ADDENDUM B

Proposal No. 8720-08-L-RFP

Proposals for furnishing the City of San Diego with **CCTV Inspection and Assessment of Selected Corrugated Metal Pipe (CMP) Storm Drain and Manholes.**

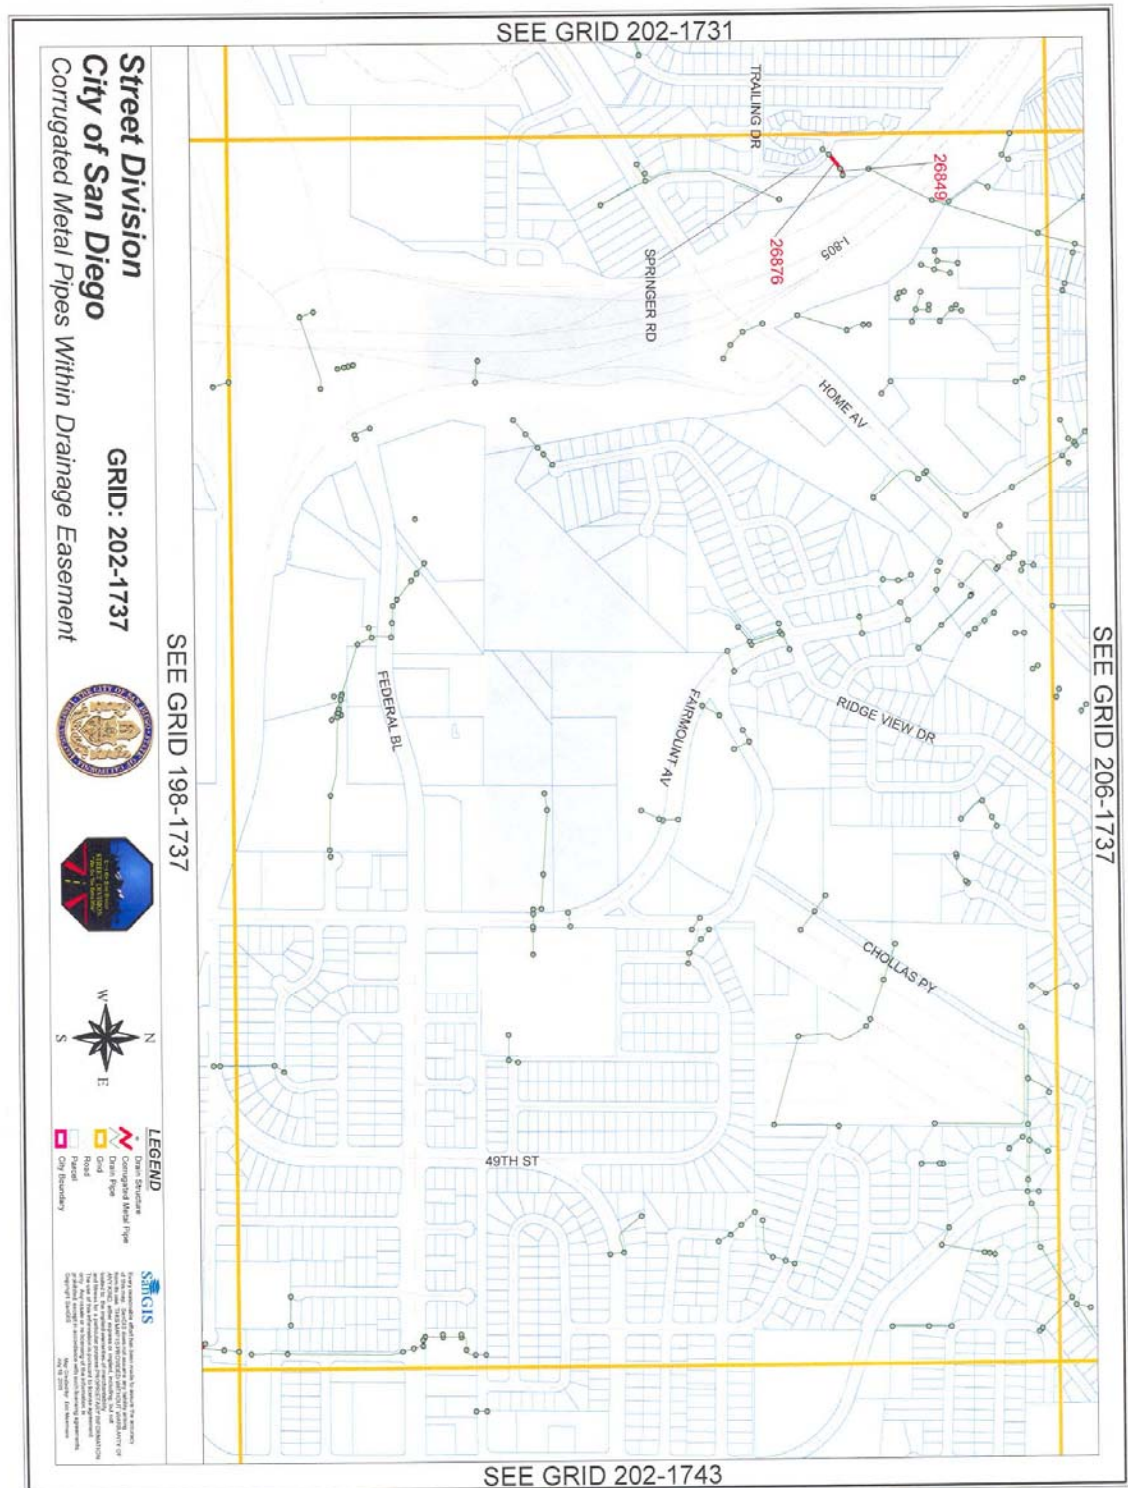
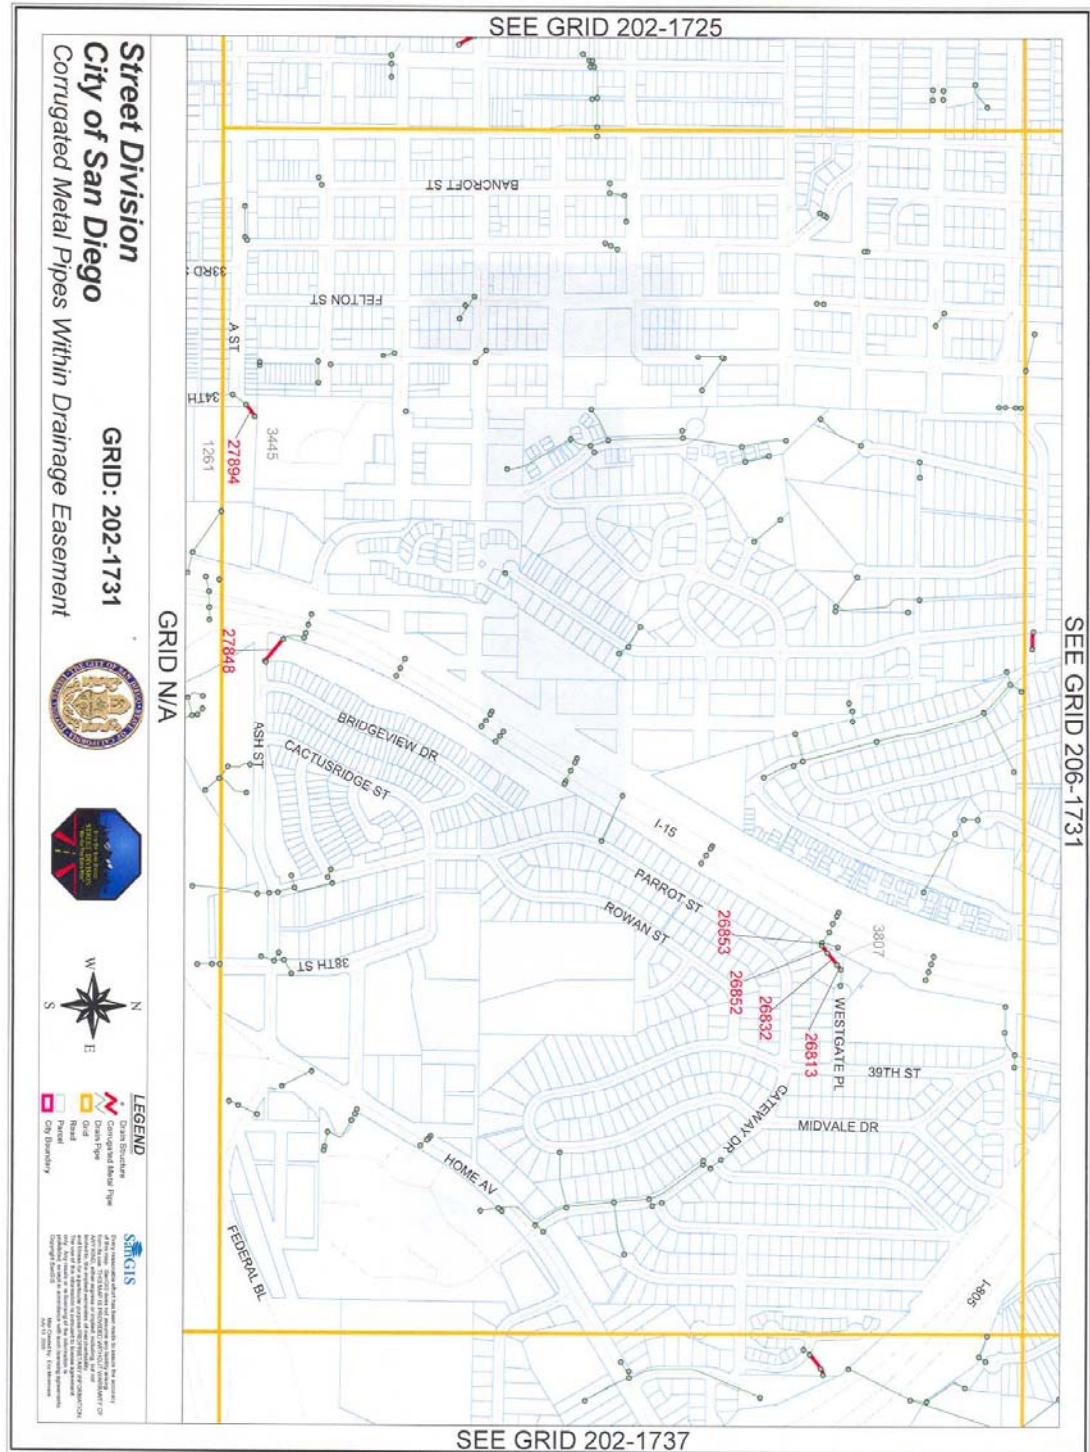
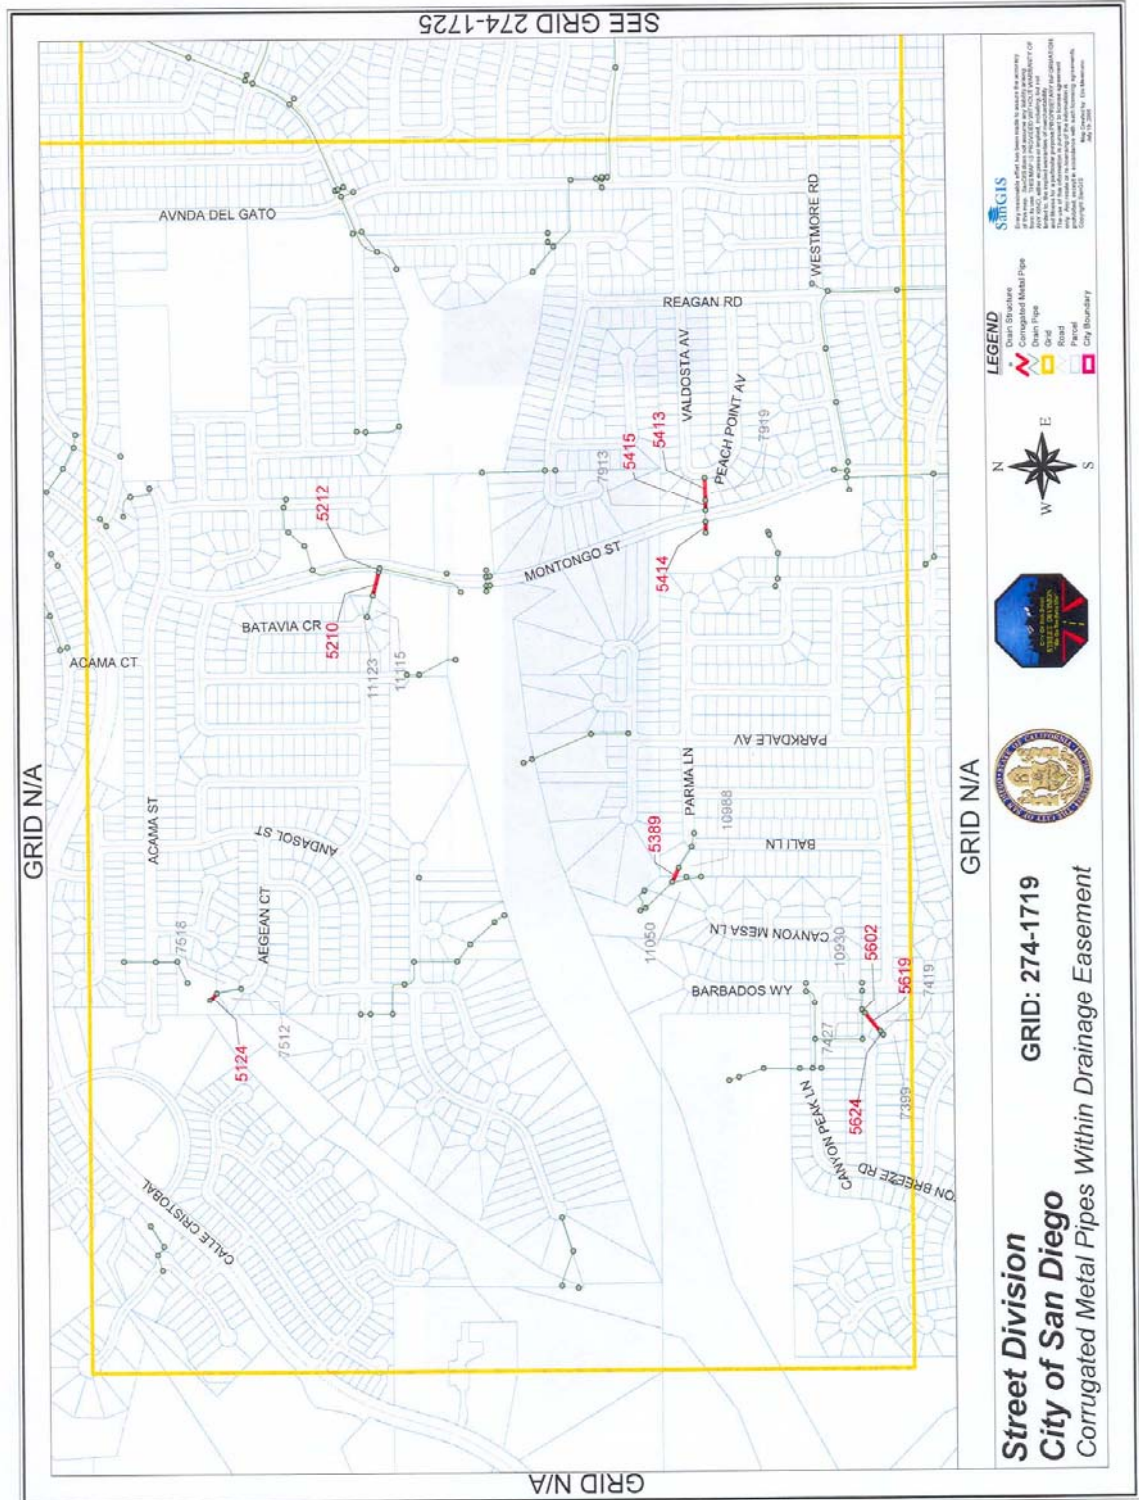
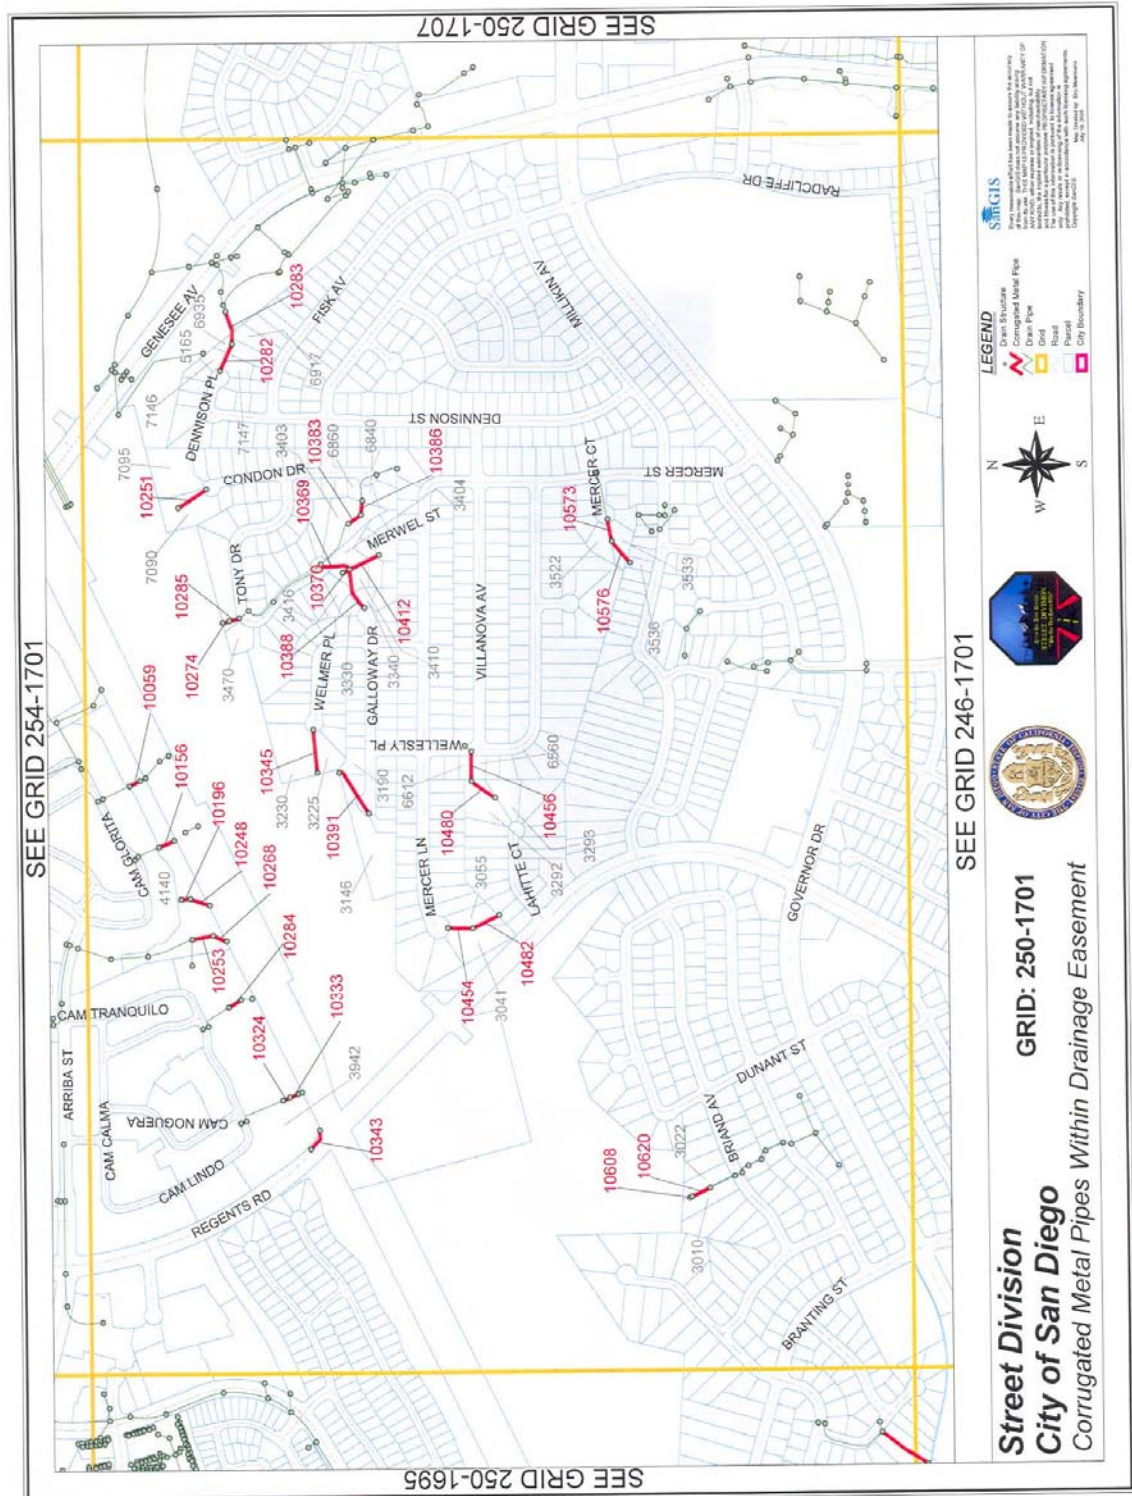
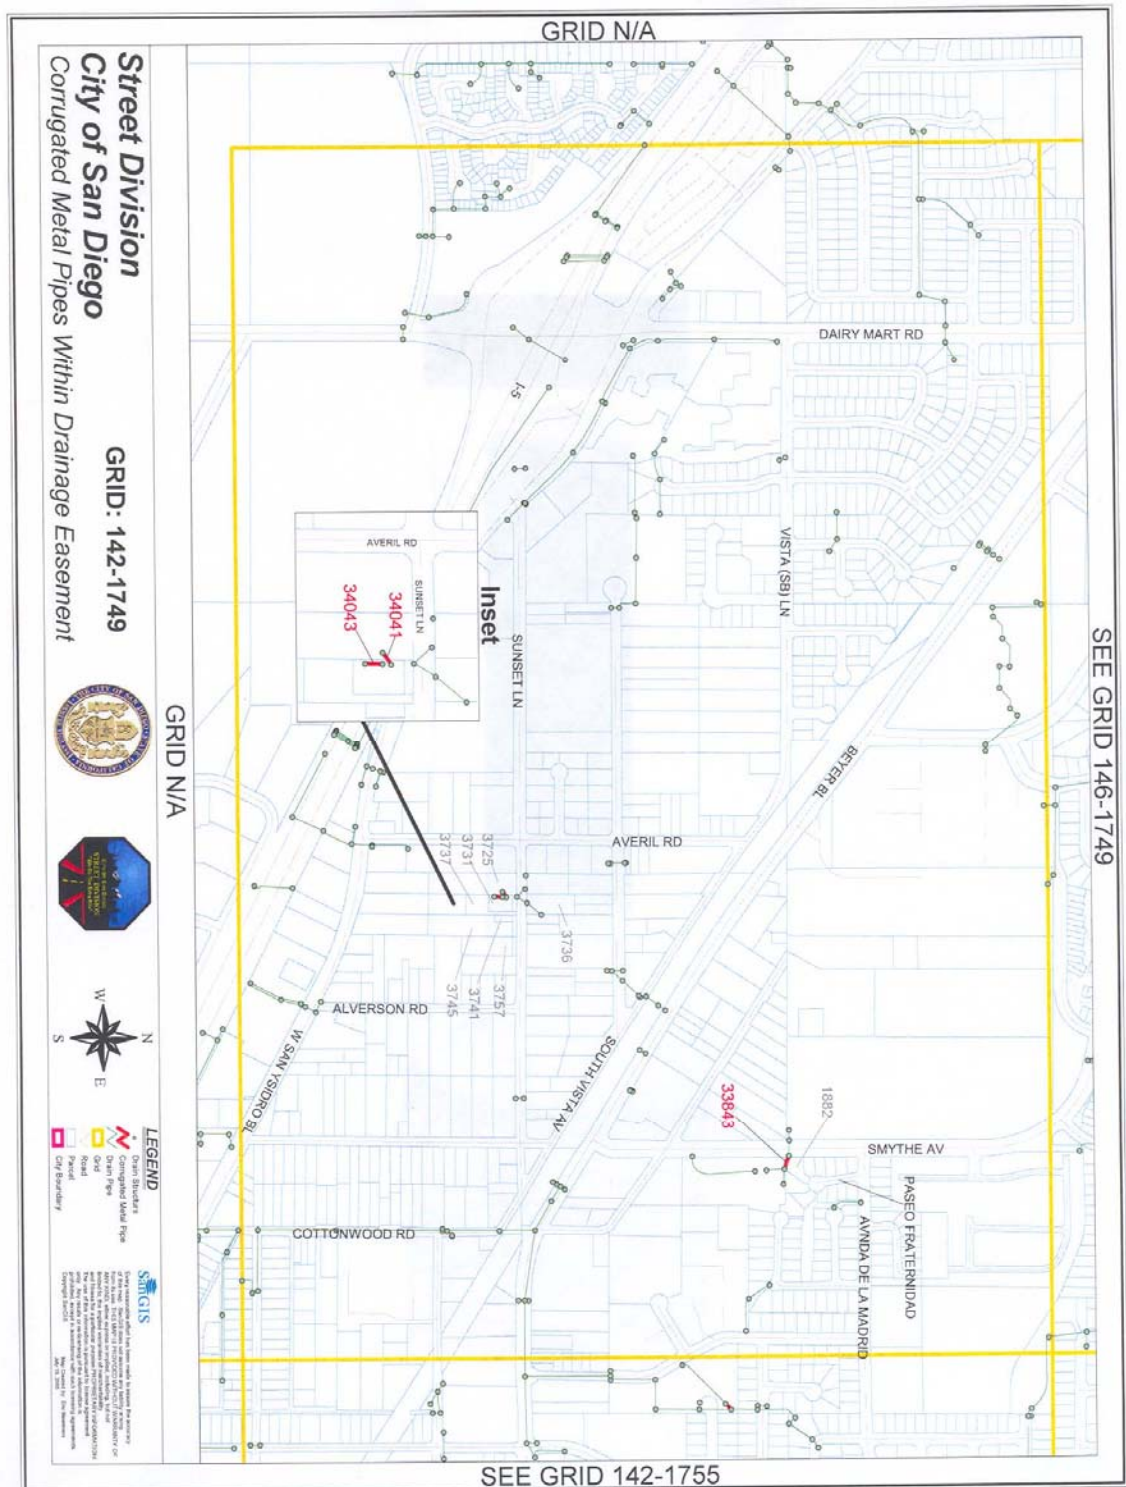
6. Q: Page 20, Section IV, paragraph B, item 2 - What size and scale will the paper maps be and what attribute data will be printed on them? Can we get a sample?

A: Two (2) key maps are approximately 16" x 22" with city boundaries, roads, freeways, and grid numbers printed on them. Individual maps are 8 ½" x 11" and show parcels, storm drain structures, and roads. There are no scales on any of the maps. A sampling of five (5) individual maps is attached as part of Addendum B.

A: There are approximately 175 individual maps. A sampling of five (5) individual maps is attached as part of Addendum B.
